PROJECT: NEW DORMITORY FOR THE DAUPHIN ISLAND SEA LAB CAMPUS
FOR DAUPHIN ISLAND SEA LAB
GMC PROJECT NO. AMOB230181

ADDENDUM NUMBER 6

**PROJECT: NEW DORMITORY FOR THE DAUPHIN ISLAND SEA LAB CAMPUS
FOR DAUPHIN ISLAND SEA LAB
GMC PROJECT NO. AMOB230181**

AD6-1 CLARIFICATIONS / RFI'S / RESPONSES:

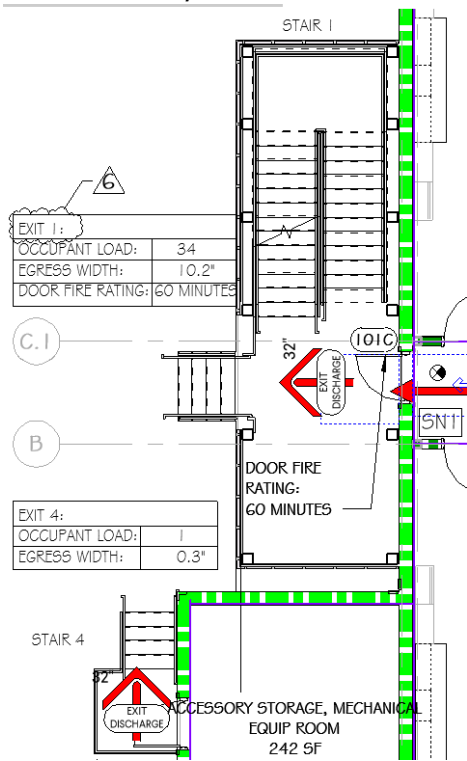
51. Replace Sheet A0.01 Demolition Site Plan with the new Sheet A0.01 Demolition Site Plan Addendum 6 dated 07/22/2025 in its entirety.
- A. General Demolition Notes were added with adding 1 tree for demolition and 2 smaller trees for Owner to transplant.
52. Replace Sheet A0.01 Site Plan with the new Sheet A0.01 Demolition Site Plan Addendum 6 dated 07/22/2025 in its entirety.
- A. Concrete Stairs were labeled , numbered and dimensioned.
53. Sheet G2.00 Life Safety – Code Analysis- The Overall Building Area square footages are to be updated with the following numbers:

OVERALL BUILDING AREA			
LEVEL	AREA (GROSS SQUARE FEET)		
LEVEL 1 -	16,362 SF GROSS	(FIRST FLOOR FIT-OUT)	+ STAIR SQUARE FOOTAGE
LEVEL 2 -	15,896 SF GROSS	(SHELL SPACE)	
TOTAL	32,258 SF GROSS (DOES NOT INCLUDE STAIRS SQUARE FOOTAGE)

7A CONCRETE STAIR PLAN /S5.3

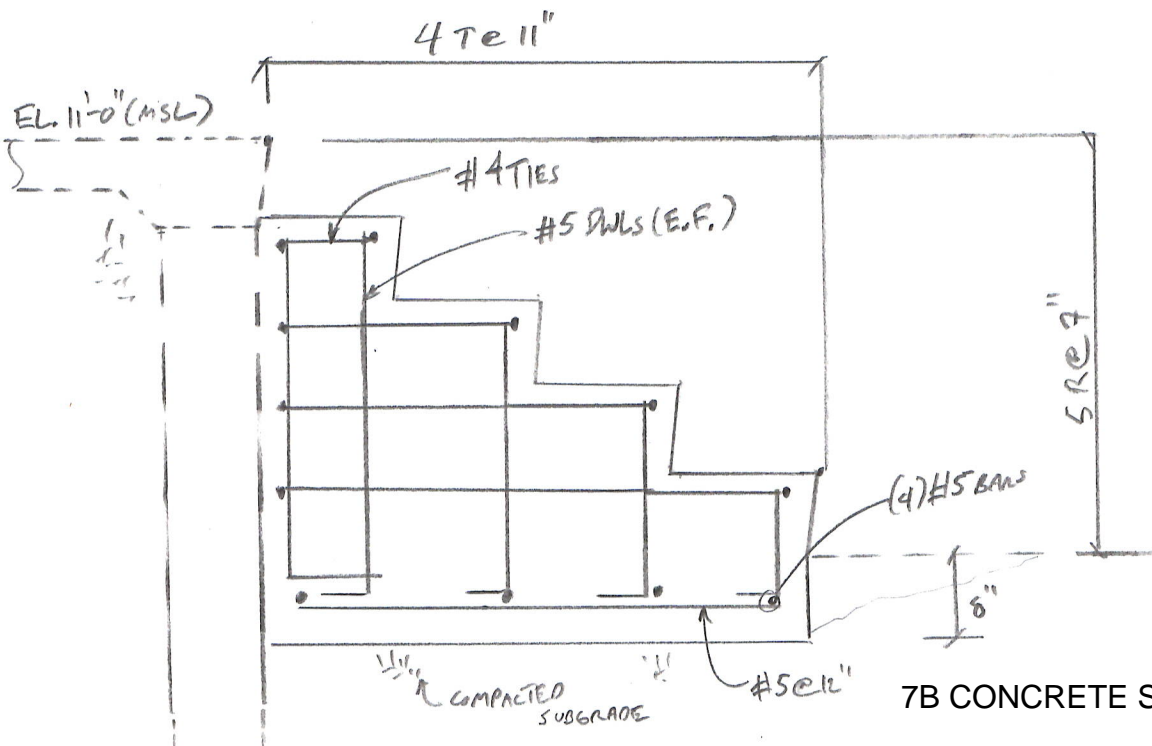
15. There are not details for the concrete steps that attach to the building. I can put a price on it but I didn't know if we could request some clarification on this?

RESPONSE: Structural Detail 7/S5.3 is attached with stair plan and section.

- A. Exit 1 - Stair 1 Ground Concrete Stair: 4'6" Wide**
- B. Exit 2 - Stair 2 Ground Concrete Stair: 4'-6" wide**
- C. Exit 3 - Stair 3 Ground Concrete Stair: 5'-6" wide**
- D. Exit 4 - Stair 4 Ground Concrete Stair: 3'6" wide**

1 W-1 SCALE: 1/4" = 1'-0"

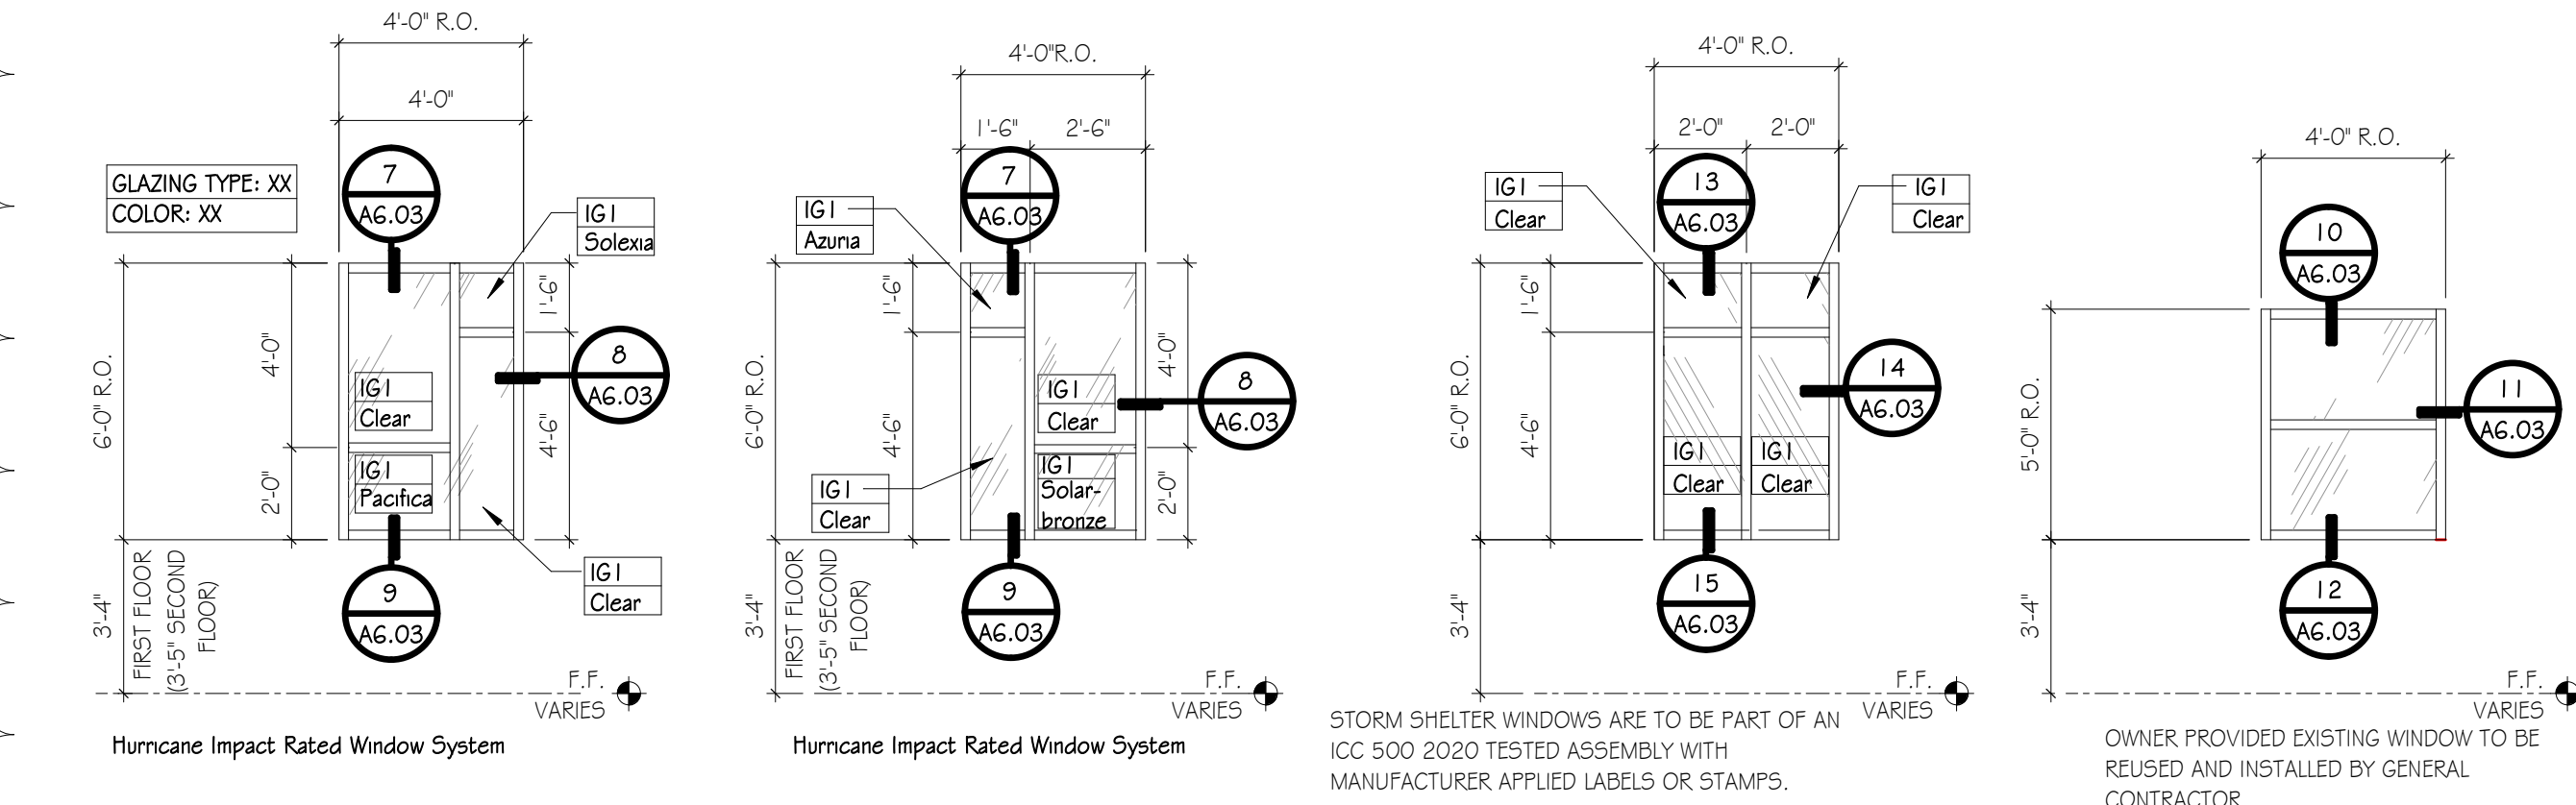
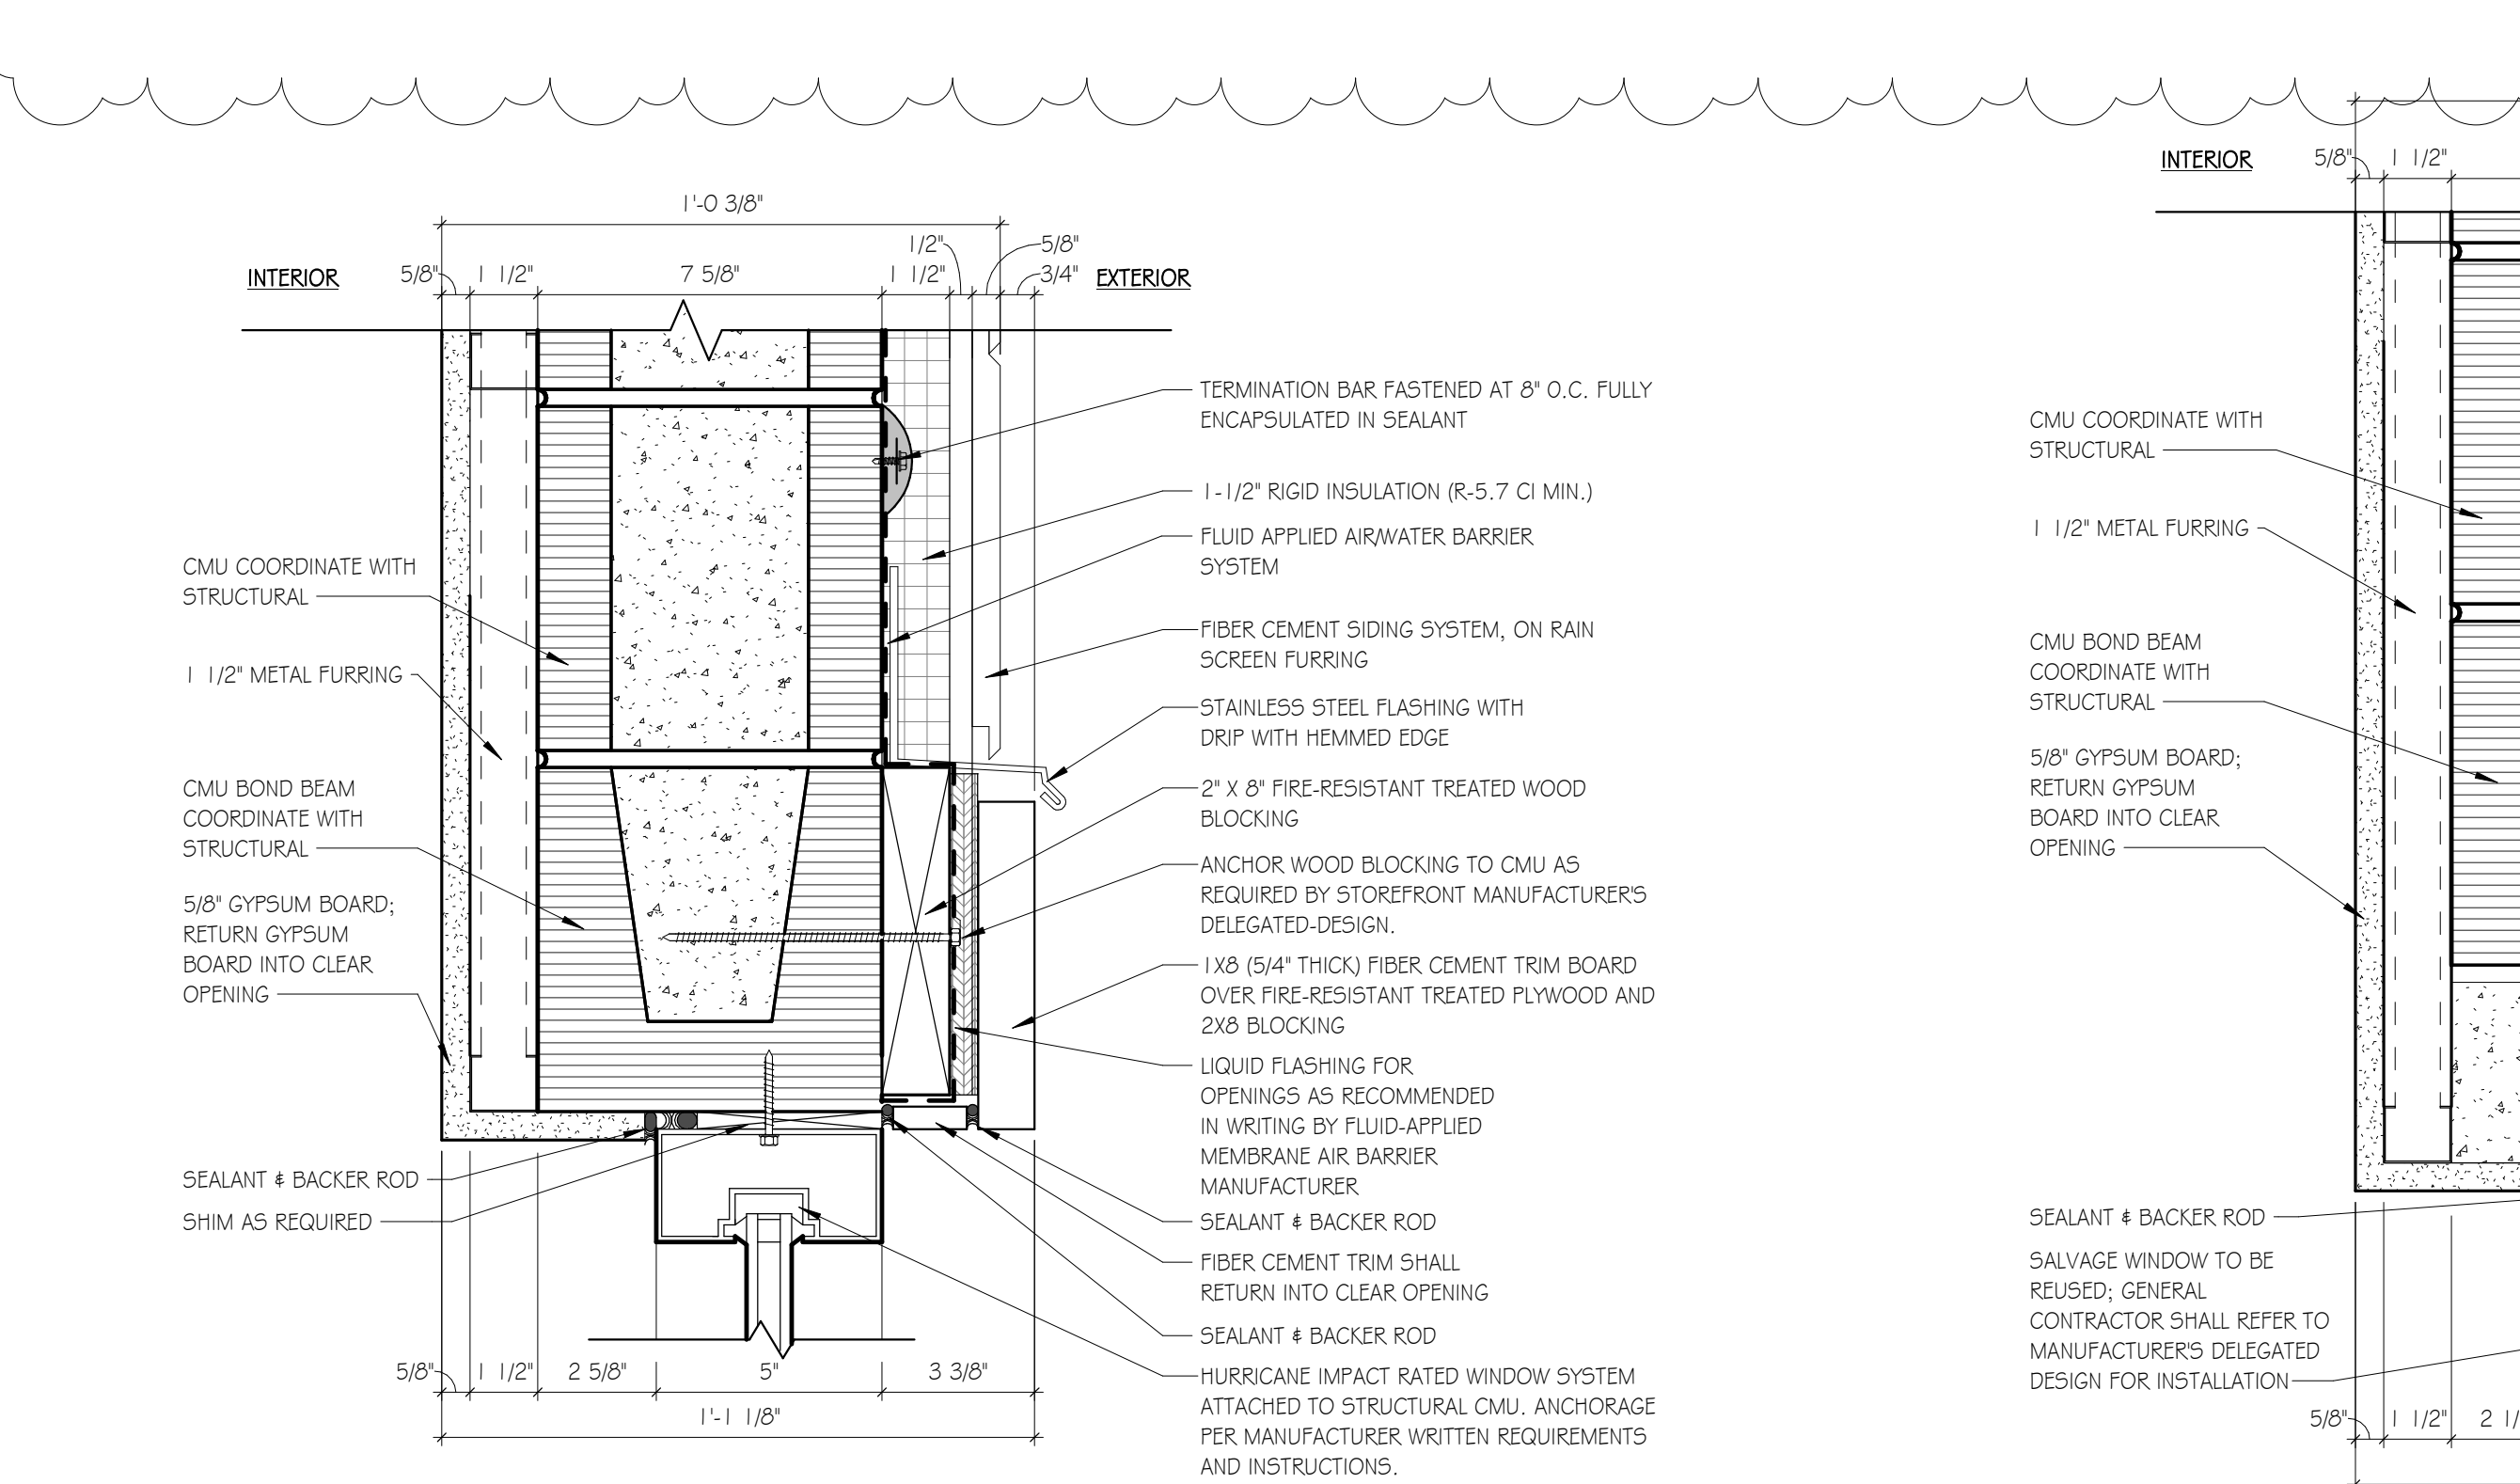
55. Sheet 6.03 Glazing System Schedule : - Replace Sheet 6.03 Glazing System Schedule Addendum 6 date 7/21/2025 In its entirety.

A. The window glazing colors have been clarified for Window Type W1, W2, W3, SF-1, and SF-2. The 5 colors are: Clear , Azuria, Solexia, Pacifica , Solarbronze.
